Hilcorp Energy  
Fogelson 2 Com #1, API#30-045-08686

Conditions of Approval:

**MV Recompletion Procedure**

# Current Schematic

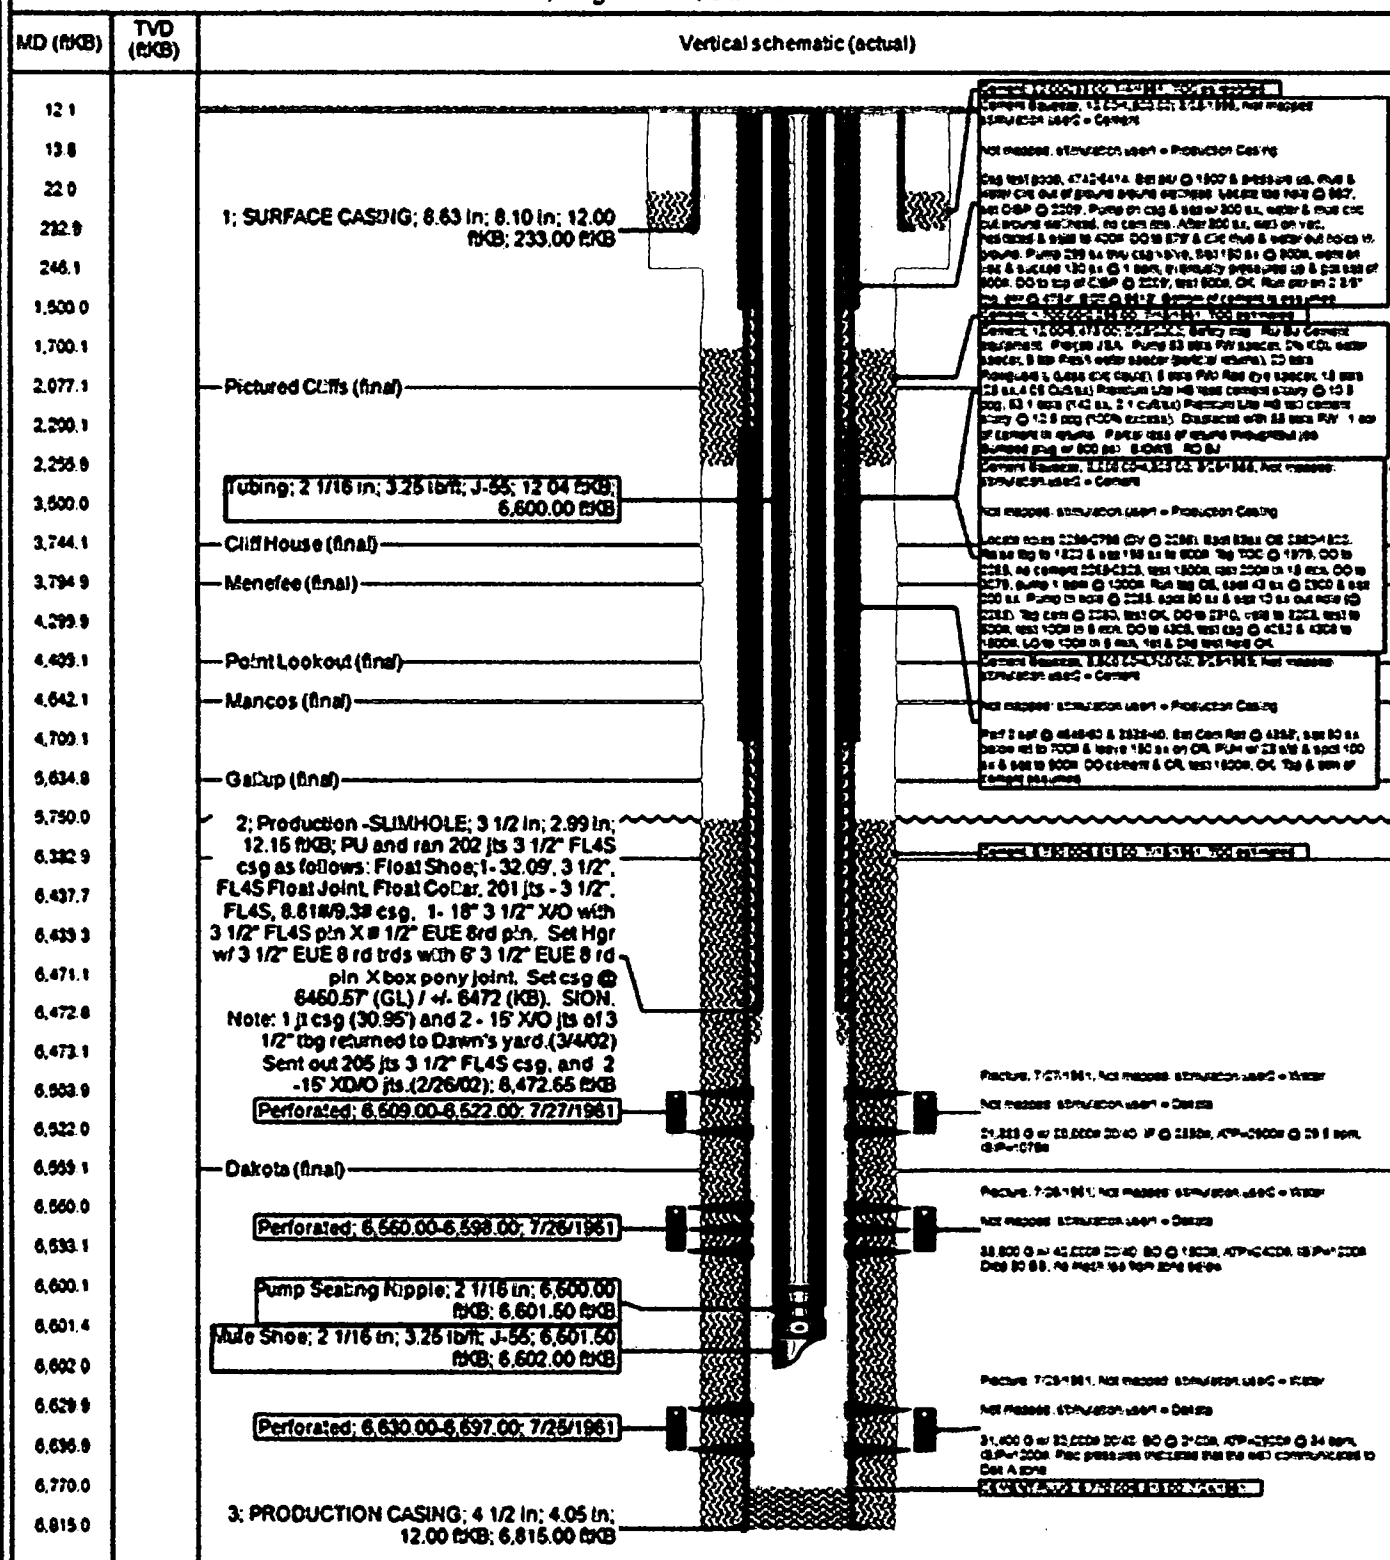
- The Submitted Notice of Intent filed was incomplete concerning the wells current cement information behind the 4 1/2" casing. Without this information the isolation of the Strata could not be evaluated.
- **To correct the issue, a revised NOI is required to be filed and approved prior to any recomplete work being performed.**

On the above well do you have any records showing the cement coverage on the outside of the 4 ½ casing? In the well file I observed several documents about casing leaks and squeezes but couldn't find any CBLs. Please note the sundry indicated the cement on the outside of the 3 ½ casing as being circulated however since the 4 ½ casing is the outermost casing it is the cement on the outside of this casing that would provide the isolation.

We are searching for a vendor that may have a tool that can read through 2 strings of casing. This isn't something that appears to be available in the Basin currently.

We are exploring other vendors to provide said tool.

Until we have something that can accomplish this for us we will have to put it in inventory.
